J-NZ0488-003-L-Rev0

Otago Regional Council Clarifications

Mine Waste Management Limited (MWM) has provided this letter report to address requests for further information (RFI) from the Otago Regional Council (ORC) received in December 2025 for the Matakanui Gold Limited (MGL) Fast Track Approvals Act (FTAA) application for the Bendigo-Ophir Gold Project (BOGP). Two RFI documents were provided by ORC (reference RMFT25.007):

Figure 1: Ardgour Aquifer mixing calculations.

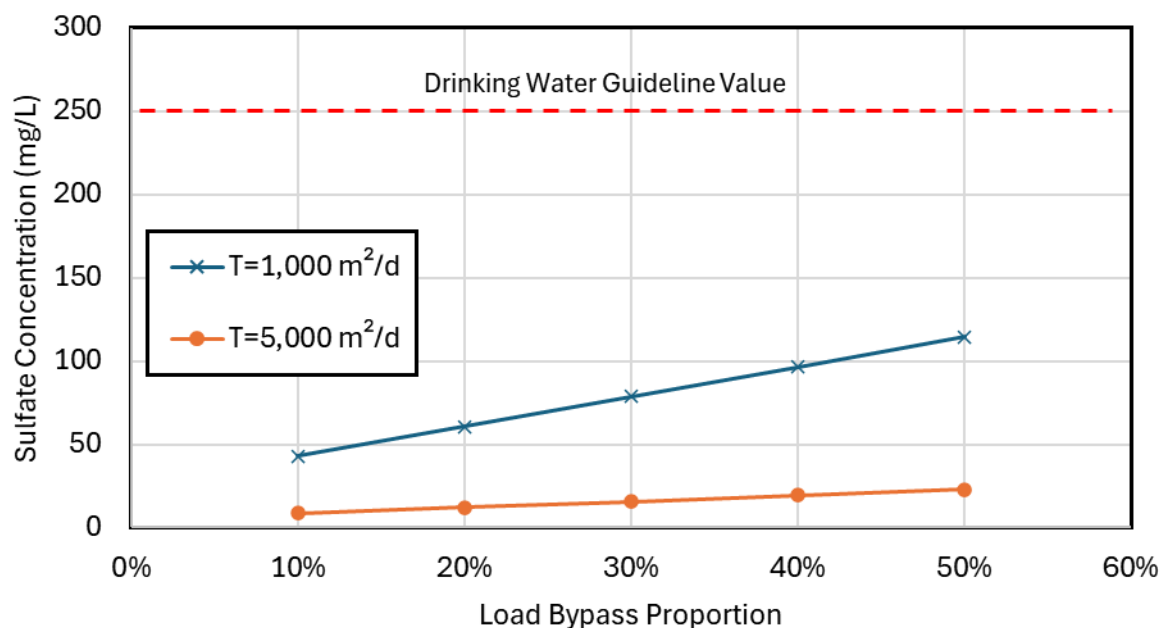
Please undertake sensitivity analysis to understand the potential adverse effects of uncaptured mine-impacted seepage on the downgradient freshwater receiving environment. This purpose of this analysis is to understand the amount of uncaptured seepage (as a percentage of total seepage) from mining features that would result in a measurable adverse effect on water quality within groundwater (the Lindis Alluvial Ribbon Aquifer or Ardgour Valley Aquifer or Bendigo Aquifer) or surface water (Lindis or Clutha Rivers) and any flow-on effects on aquatic ecology in the surface water environment.

Despite the high levels of seepage collection anticipated, screening level sulfate mixing calculations for the Ardgour Valley Aquifer³ for varying levels of seepage collection are calculated as follows (Table 1 summarises the basis for the calculations):

Results are presented in Figure 1 for Shepherds Creek load reporting to the Ardgour Valley Aquifer. Calculations suggest even for relatively high levels of uncaptured seepage bypass (e.g., 50%) reporting to the Ardgour Valley Aquifer, sulfate concentrations are less than half the drinking water guideline value of 250 mg/L. For lower levels of bypass (or high seepage capture rates), say 15% bypass or less, calculated sulfate concentrations are approximately 50 mg/L or less, or lower than the drinking water guideline value by a factor of 5 or more.

Figure 2: RAS Pit Conceptual Model

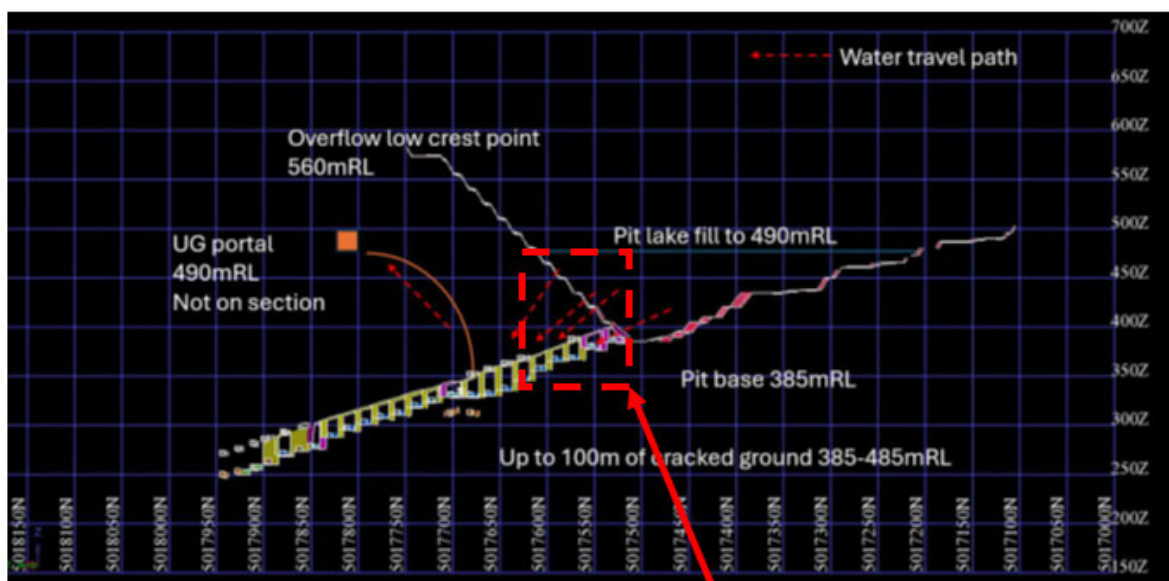
In calculating the source terms for the RAS⁴ underground workings, it has been assumed that water quality is dominated by RAS pit lake quality; however, this does not consider the impact of tailings paste on water quality, nor does it consider the relative volumes that the RAS pit and RAS underground workings will contribute. Accordingly, please:

- a. Compare the expected RAS pit lake water discharge volumes with the expected contribution from the RAS underground workings.
- b. Assess the effect of the discharge of tailings paste into the underground workings on the quality of water in the underground workings.
- c. Recalculate source terms, and update any assessments that rely on these, if necessary.

Paste backfill is likely to have a permeability that is several orders of magnitude lower than the permeability of the (fractured) Crown Pillar that connects the underground to the RAS Pit Lake. Conceptually the water quality will be dominated by the RAS Pit lake water. This is shown in Figure 2.

As the Crown Pillar is robbed, K of overlying rock mass will increase, providing hydraulic connection.

Figure 4: Pit lake filling sensitivity analysis.

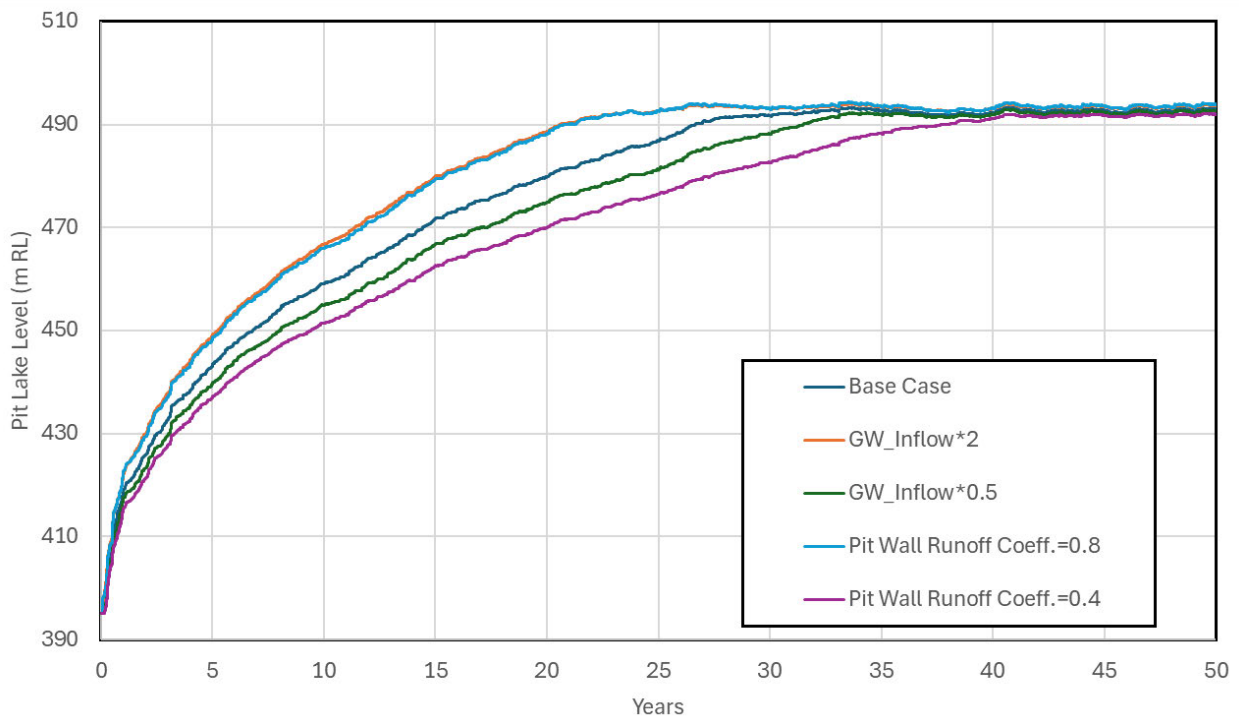
Report B.04 states that an estimated period of 50-60 years will elapse prior to the RAS pit lake and underground workings would connect to the surface water system. Please provide an assessment from a suitably qualified and experienced person that addresses the following matters:

- a. The margin of error in this 50-60-year estimate.
- b. Whether this margin of error has been incorporated into any other assessments that have relied on this estimate, including but not limited to dam⁵ (pit) safety, contaminant transport, downstream ecological assessments, and monitoring and maintenance requirements across the mine site.
- c. ~~How any proposed underdrains have been taken into account in the time estimate~~⁶.
- d. If stream depletion effects are anticipated for 50-60 years post-closure, please explain the reasoning behind Kōmanawa's statement that surface water flows in both arms of Shepherds and Bendigo catchments would increase.

MWM note that Report B.04 uses outdated pit lake filling estimates of 50 to 60 years related to a previously considered portal elevation. The current portal elevation planned is 490 m RL, and modelling completed by MWM (2025b) estimated the filling rate to be 25 years based on this elevation.

Sensitivity analysis of the model developed by MWM is shown in Figure 4 that considers the following scenarios:

As can be seen from the presented analysis, model results suggest the pit lake filling time could vary between 25 to 40 years.

Figure A1: Groundwater - Vertical Hydraulic Gradients
Bendigo-Ophir Gold Project

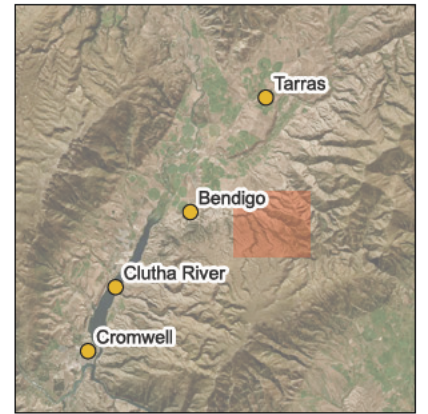
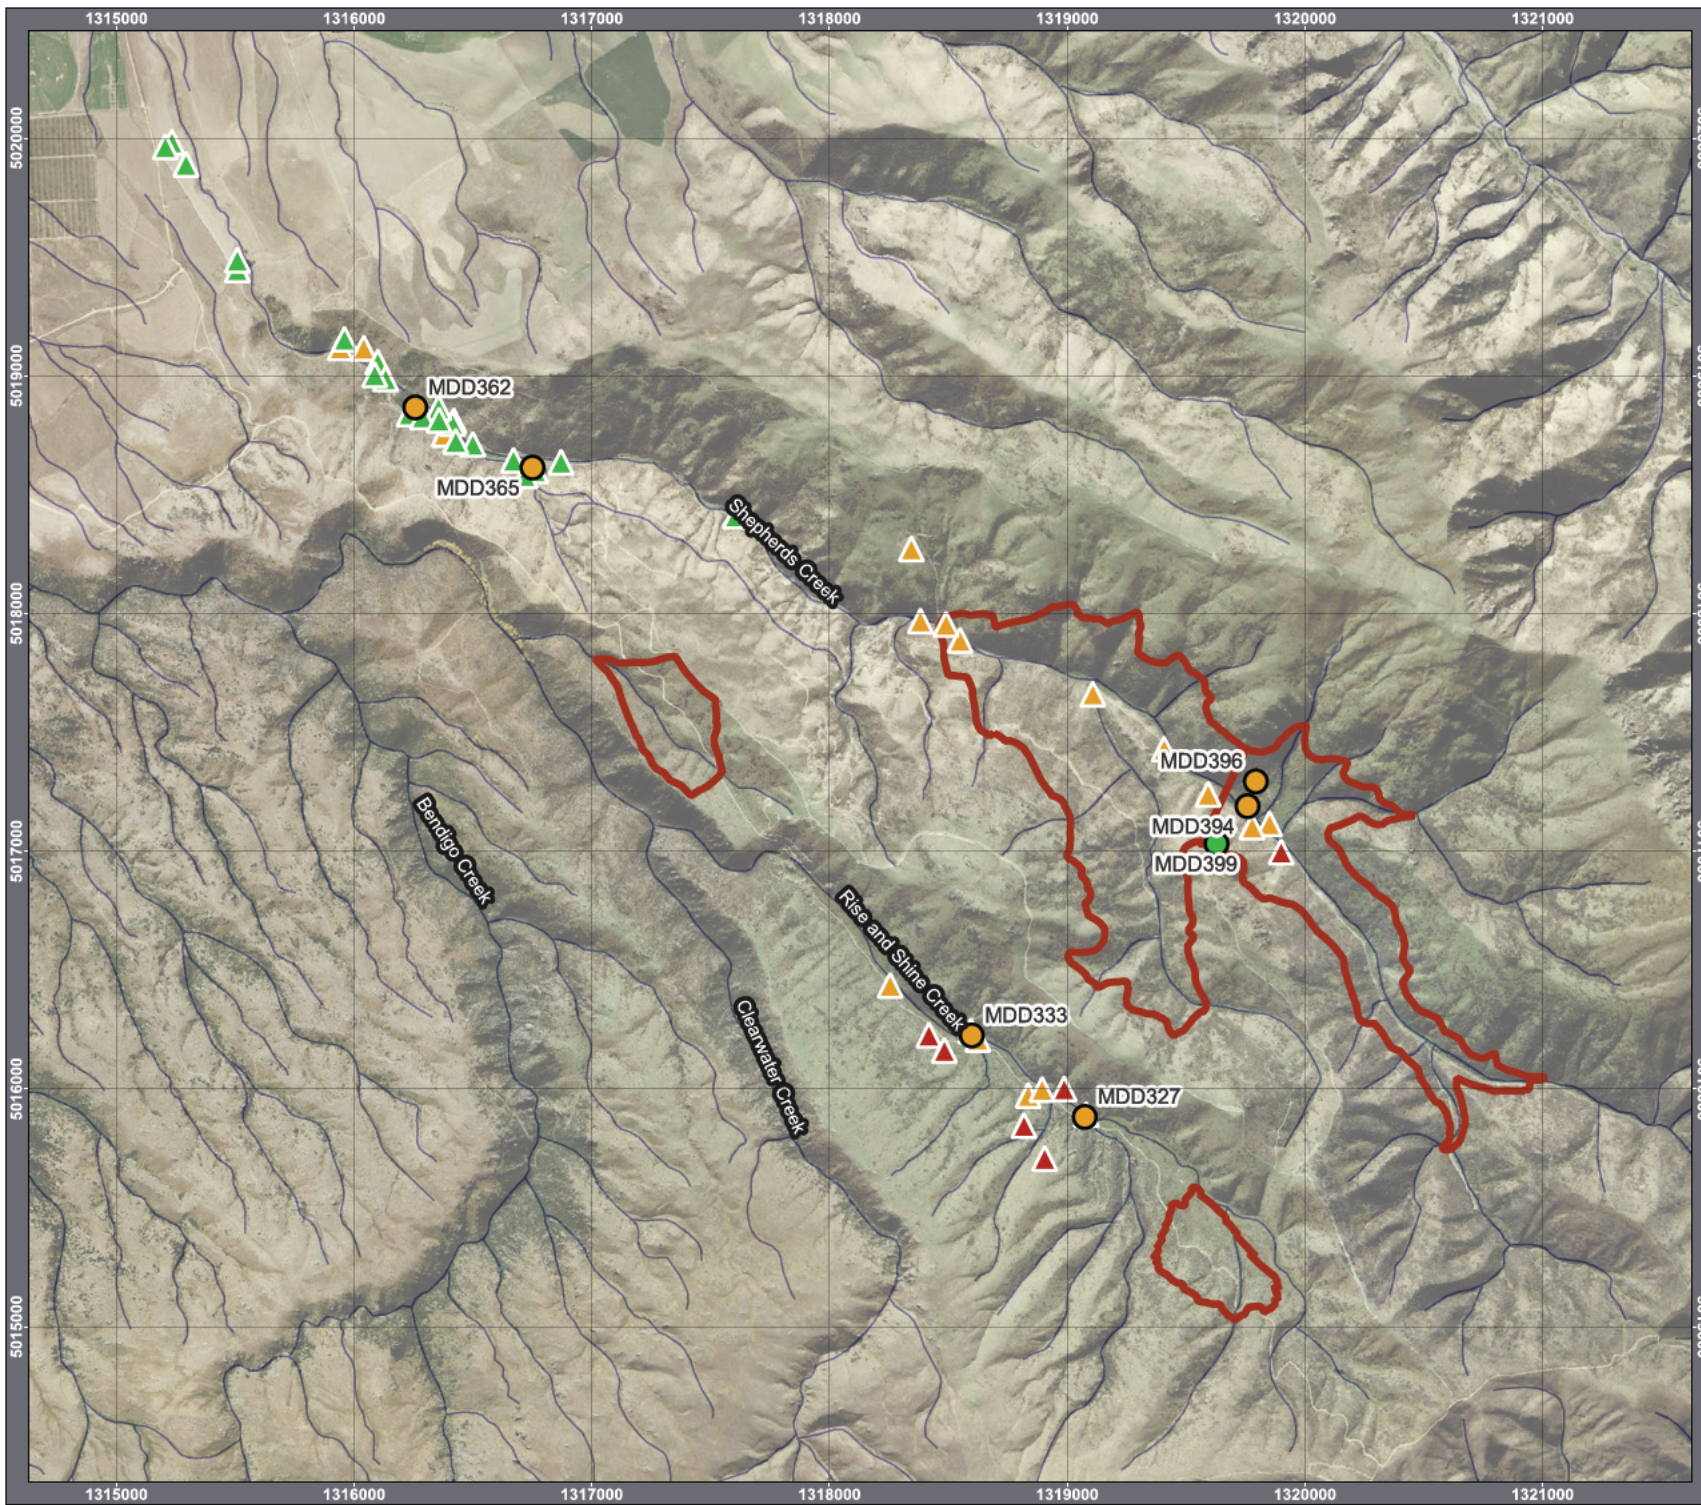
Please provide any additional ground investigation or groundwater monitoring (level or quality) data that has been collected since the MWM and Kōmanawa assessment were undertaken. Please also indicate whether ongoing groundwater investigations and monitoring are occurring, particularly in the vicinity of planned mine waste storage facilities. These data would assist in understanding whether mine waste storage facility seepage collection systems will achieve the anticipated collection requirements. It is noted that MWM recommended that two years of baseline data be collected for a robust data set.

Additional ground investigations have been completed by EGL (2025b). Figure A1 and A2 in Attachment A of this letter report presents salient hydrogeological data from this work that support understanding the hydrogeological setting at the BOGP.
